RECORD OF DECISION

STPP 3-2(27)28

Fairfield to Dupuyer – Corridor Study

D. COMMENTS ON THE FINAL EIS

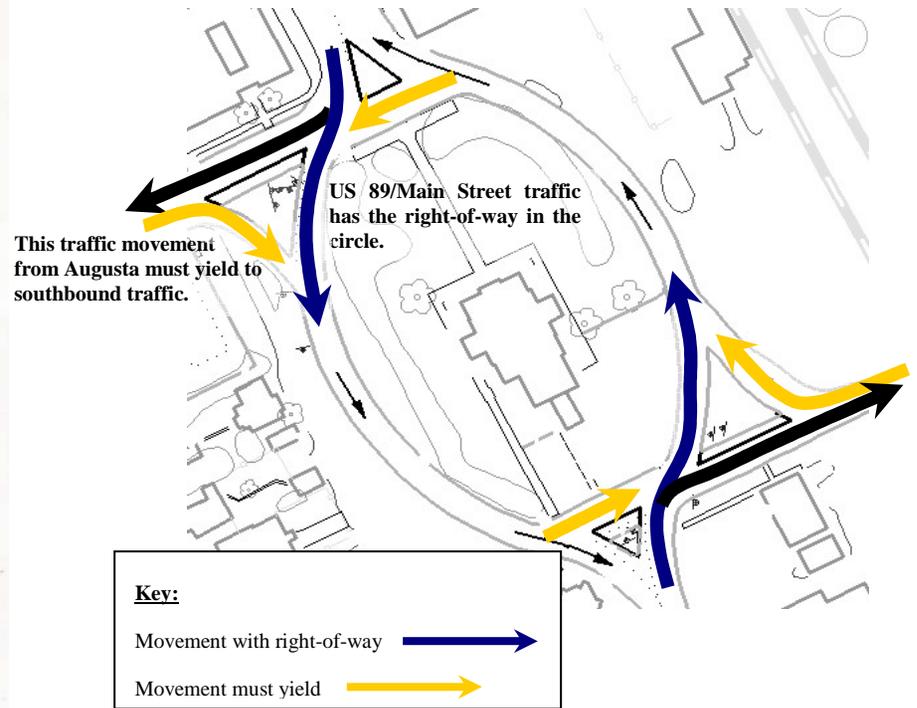
1 I have recently read the Final Environmental Impact Statement Re: the Fairfield to Dupuyer Corridor Study. I feel that there has been a lot of work and research put into this document and am in agreement with your choice of alternatives. I would like to know a couple of things: One is if the traffic from Augusta will be turning to their right and going around the Court House to come up on Hwy. 89 through town, what does the traffic coming from the north on Hwy. 89 do when they want to go to the Drive Inn, the lumber yard, and even the Court House? Can they make a left turn to yield with the Augusta traffic? Also, I am not sure what your plan is where we leave Hwy. 89 to go up Teton Canyon to the lake and various other places west.

1 The figure below illustrates the traffic movements and right-of-way around the Courthouse. The movement you described – coming from the north on US 89/Main Street destined for the Log Cabin Café – has the right-of-way. Traffic entering the circle from the west (presumably from Augusta) would yield to traffic coming from the north.

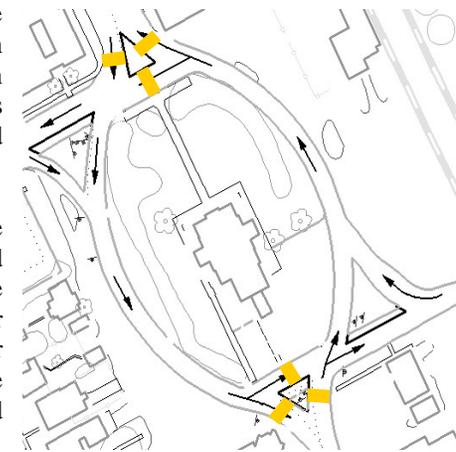
8 B.) The Court House is located in such a manner that there should be 4 distinct crosswalks leading from it, with Pedestrian signs, at 10 o'clock - 2 o'clock - 5 o'clock as well as 7 o'clock, if you were facing north to the Court House with Fairfield at your back (south). From the Court House complex and lawn, the business district is at 2 o'clock - the Police Station is located at 5 o'clock - the Log Cabin Cafe at 7 and the Nursing Home and Swimming Pool at 10 o'clock.

8 Pedestrian crossing in a traffic circle is always a challenge due to the fact that traffic is never required to stop for most movements. In the case of this modified traffic circle, or couplet, it may be best to locate crossings of US 89/Main Street at the north and south ends of the courthouse as depicted below. This minimizes the traffic movements the pedestrians must monitor and negotiate as they cross. They would be provided refuge on the traffic islands, and then only cross the low volume one-way segments at those ends.

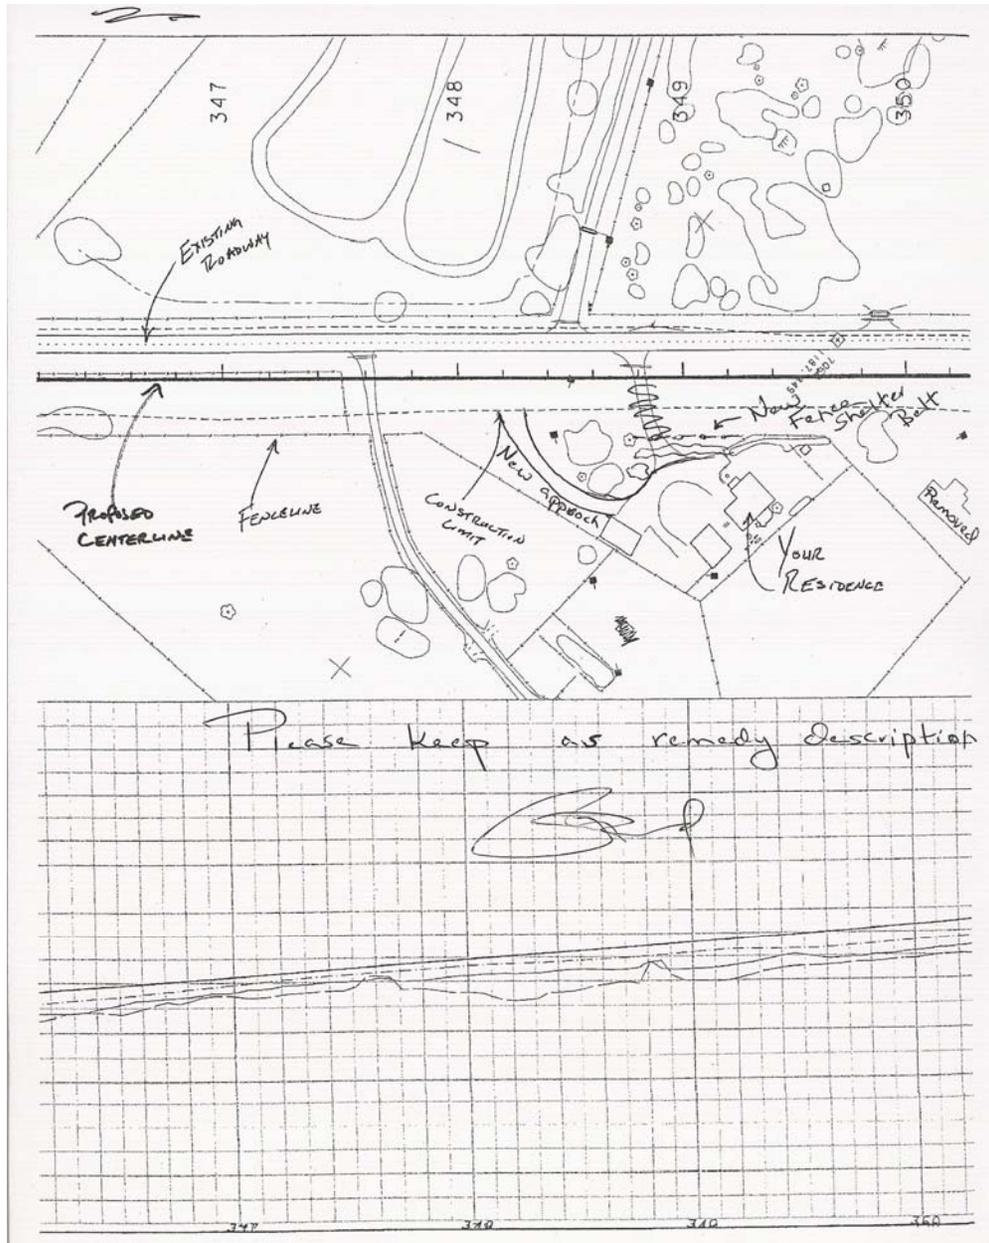
A. Changing the location of our approach to the southeast corner of our property would adequately address the concerns presented in comment "3". We would require assurance of a new approach easement and an explanation regarding the D.O.T.'s responsibility both for removing the present approach & providing the structure for a new approach both on state property & into or on our property well in advance of actual construction.

This is a design detail that will need to be negotiated during the project's final design and right-of-way negotiation phase. Your request is part of the official record and will be considered as the project progresses.
